DELEGATED DECISION REPORT

203182

Land adjacent to Burnt House, Bridstow, Ross-on-Wye, HR9 6QQ

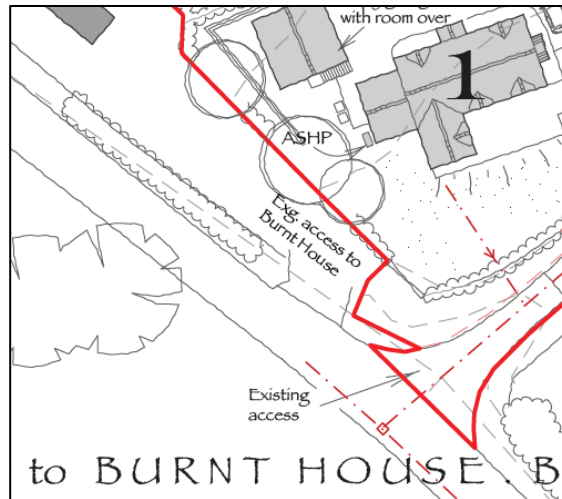
Following updated details and confirmation that hedgerow will not be removed

If no hedgerow is to be removed then I have no objection but do request that a condition is used to ensure this remains the case.

Likewise a condition to ensure details of specifications, planting, protection, establishment and maintenance of all new hedge planting with hedgerow standard trees is requested.
